Quantum Barriers Engineering toward Radiative and Stable Perovskite Photovoltaic Devices

REVIEWER COMMENTS

Response to Reviewers' Comments and Summary of Changes

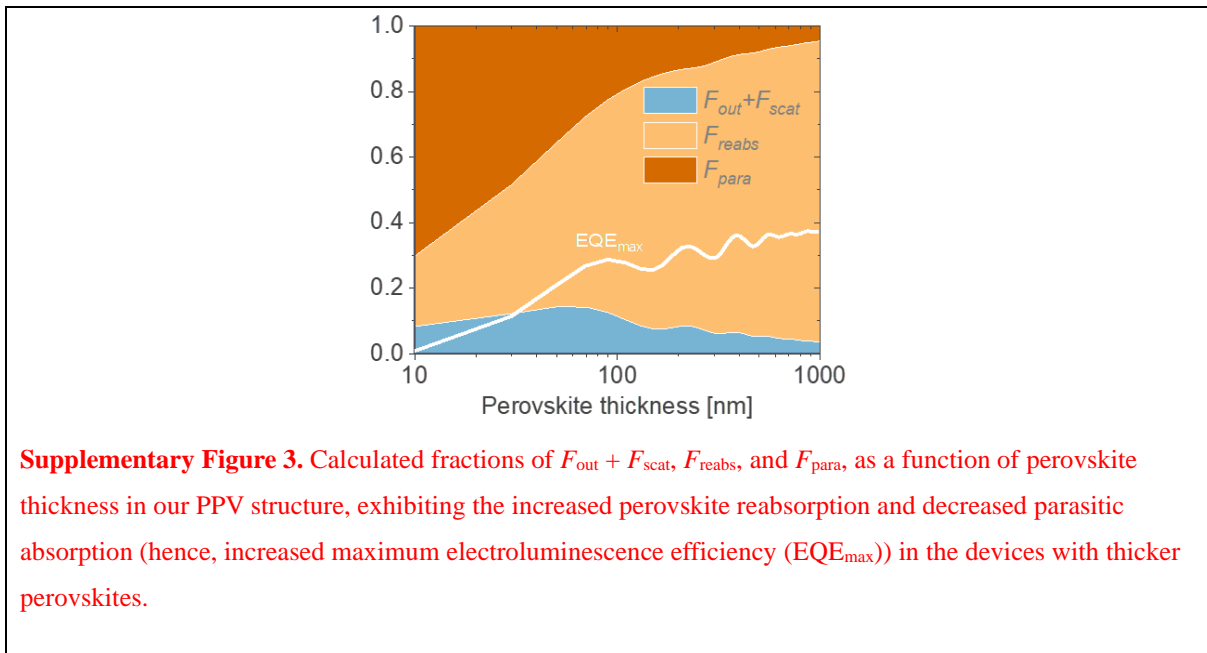
Figure 1, limit of $\eta_{rad}=1$. In this limit, ELQE approaches the ratio of outcoupling/(outcoupling+parasitic absorption) as there is nothing else that can happen. The thick layer leads to less outcoupling, if parasitic absorption was assumed constant, the thick layer would always be worse. Why is it better? It must mean, parasitic absorption becomes much less for the thick film. How can we understand this? Let us make an example. Would it be possible to have a figure with the three fractions parasitic absorption, reabsorption within the active layer and outcoupling (sum of LEE_0 and S) as a function of thickness? I think that the thicker you make it, the more you suppress parasitic absorption in % of total emission events and that is key at least for my understanding. In the absence of parasitic absorption, there would be no difference between thick and thin at least in the high η_{rad} limit. That also means that the better the internal yield becomes, the more it will be important to identify the sources of parasitic absorption. This is a well-known concept from GaAs

single junction PV, where the introduction of the thin-film GaAs devices by Alta led to highly improved Voc values. So if you were able to say more about the main sources of parasitic absorption in the simulations that would be helpful.

R 1.2) We agree the points that the reviewer raised and thank for the suggestions.

First, as the reviewer pointed out, the maximum EQE is simply determined by the ratio between direct outcoupling and parasitic absorption. Hence, the higher EQE for solar cells can be attributed to the significant reduction in parasitic absorption, which was not sufficiently clarified in the previous version of our manuscript. The reduction in parasitic absorption comes from the increased perovskite reabsorption in the trapped mode, as shown in Figure 1a. Since most of the photons in the waveguide mode in the PPV are reabsorbed by a thick perovskite before getting absorbed by other layers, the relative fraction of parasitic absorption becomes very small in the PPV. While perovskite reabsorption can reduce both outcoupling and parasitic absorption, since the internal optical path length is much longer for the waveguide mode (typically several micrometres or longer) than for the air mode (shorter than perovskite thickness), the relative reduction is more significant for parasitic absorption than for outcoupling. We have updated the manuscript by introducing it, as shown below.

“Notably, while the $F_{\text{out}} + F_{\text{scat}}$ of the PPV is still low (4.9 %), the fraction of F_{reabs} is considerably larger in the PPV (88.5 %) than in the PeLED (36.7 %), **mainly** owing to the thicker perovskite absorber (Supplementary Figure 3). **That results in a significantly reduced F_{para} from 45.9% (in the PeLED) to 6.6% (in the PPV), while photons in the trapped mode get mostly reabsorbed by perovskite before other layers. The reduced optical loss** provides more opportunities for photons to be recursively recycled when η_{rad} is sufficiently high. Accordingly, while the thin PeLEDs are brighter than the PPV architectures at low η_{rad} , the ELQE of the PPV rises sharply at high η_{rad} (i.e., with more efficient recycling) as shown in Figure 1b.” (page 5)

Moreover, the different charge transporting layers and electrodes of the PPV and PeLED structures that we assumed may complicate the analysis for their different optical properties. To better distinguish the impact of perovskite thickness, we added the simulation data for varying perovskite thickness in PPVs maintaining all other layers, as the reviewer suggested. Please refer to our new Supplementary Figure 3 shown below.

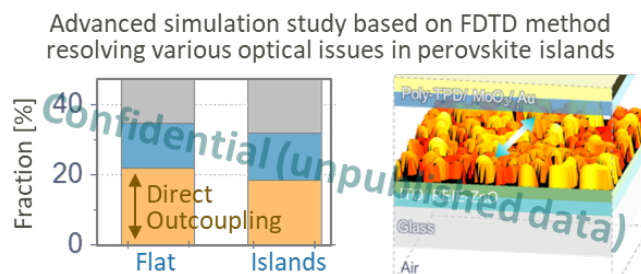
1. I'm not sure if the lengthy discussion about the difference between PPV and PLeD is necessary because the key message of this work is very simple -- the authors find a passivation method (using C18) to reduce the non-radiative recombinations so even the film is thick the light emission is still efficient, because of photon recycling (BTW, PR is already well-known in III-V and PVSK PV devices and there is no much new on the physics front).

A slightly confusing part is that the authors assume a flat film with a lower thickness for LED, but in reality the most efficient LEDs are based on island structures (e.g., *Nature* 562, 249–253 (2018); *Nature* 615, 830–835 (2023)). The outcoupling and ELQE are eventually very much dependent on the geometry and morphology of the devices. Therefore, I am not sure if the discussion related to Fig 1 is necessary.

R 4.1.2)

As the reviewer pointed out, island nanostructures are currently popular for NIR LEDs, while planar structures are still popular for most visible LEDs. Here we chose a planar structure to generalise our analysis and focus on the impact of perovskite thickness itself, excluding other side effects arising from specific structures. To avoid a confusion, we have revised the expressions as shown below.

“Based on this approach, we could obtain the angular distributions of internal radiation formed in two different perovskite diodes – the one having a thick and rough perovskite (conventional PPVs) and the other having a thin and smooth perovskite (conventional PeLEDs) (Figure 1a; refer to Methods and Supplementary Figures 1-2 for the full details).” (page 4)

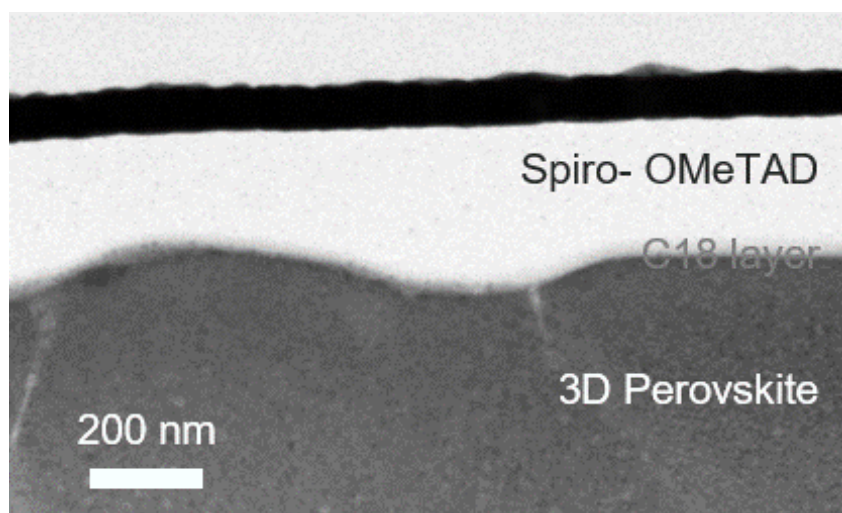
2. Regarding the use of C18 instead of C8, I certainly understand C18 is longer and can improve stability. But it is not very clear why it can better passivate the 3D perovskite.

R 4.2.1)

As the reviewer pointed out, the long organic chains do not have a benefit in conventional trap passivation, compared to short chains. Also in our Figure 2d, the passivation effect of our C18 is even worse than conventional C8. Instead of trap passivation in 3D perovskites, C18-based 2D perovskites improve the charge selectivity at the interface based on thicker quantum barriers shown in Figure 2c. Hence the interface quenching is largely reduced when spiro-OMeTAD is coated on perovskites (Figure 2e-g). This is our design rule for interfacial layers, distinguishable from typical approaches focusing on trap passivation effects. We updated the manuscript to better clarify our main point as shown below.

“That is consistent with the well-known trap passivation effects of organic treatments.”^{22-25,29-31}

Here, there is no benefit shown for our L-site exchange process in terms of surface passivation, compared to conventional C8-only approaches.” (page 10)

“Figure 2g summarizes the major role of MQWs that we propose, preventing radiation quenching at the interfaces by increasing charge selectivity.” (page 11)

“Such a boosted optical benefit enables a net increase in the average efficiency from 25.57 % to 25.81 %, overcoming the loss in *FF*. These results validate our proposed design rules with thicker quantum barriers, despite the potential losses in charge transport and trap passivation compared to conventional approaches with thinner barriers.” (page 14)

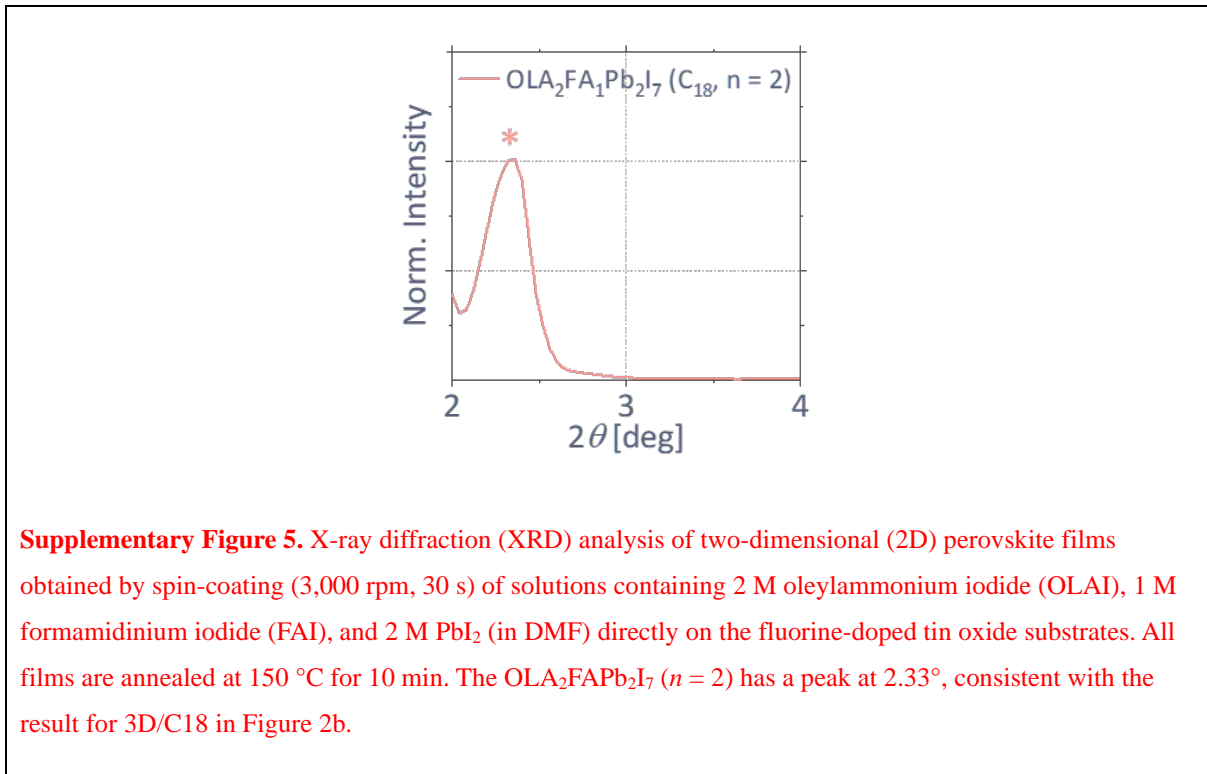
3. To more rigorously confirm the formation of $n=2$ phase on the 3D perovskite, single crystal XRD of the $n=2$ should be obtained and compared with the powder XRD obtained from the 2D/3D film. This is less critical given the nature of this paper is more on the device engineering. But it could be much better if the real crystal structure can be resolved and confirmed before a novel structure is being claimed.

R 4.3)

We respect the reviewer's valuable suggestions. Based on the reviewer's suggestion, we have additionally prepared an OLA-based 2D perovskite crystals with $n = 2$ and added its XRD data to the manuscript, as shown below. Although we were not able to obtain the single crystal data in a publishable quality due to limited synthesis techniques, instead, we could supplement our main claim by measuring a 2D polycrystalline perovskite based on the precisely controlled precursor composition. The XRD peak of our $\text{OLA}_2\text{FAPb}_2\text{I}_7$ ($n = 2$) sample (2.33°) is shown to be well consistent with the peak observed in our C18 MQWs formed on the 3D film (2.33°) shown in Figure 2b. This experimentally demonstrates that MQWs based on $\text{OLA}_2\text{FAPb}_2\text{I}_7$ crystals with an octahedral sheet number of 2 are formed through the designed L-site exchange process.

“The result indicates that the C8 spacers of 2D perovskites are effectively substituted by C18 during the process, whereas their octahedral structure remains unchanged. **The effectiveness of our process is further supplemented by the XRD analysis of a separately prepared OLA-based 2D perovskite with $n = 2$, exhibiting the same peak position (2.33°) as our C18 MQWs formed on 3D perovskites.**” (page 9)
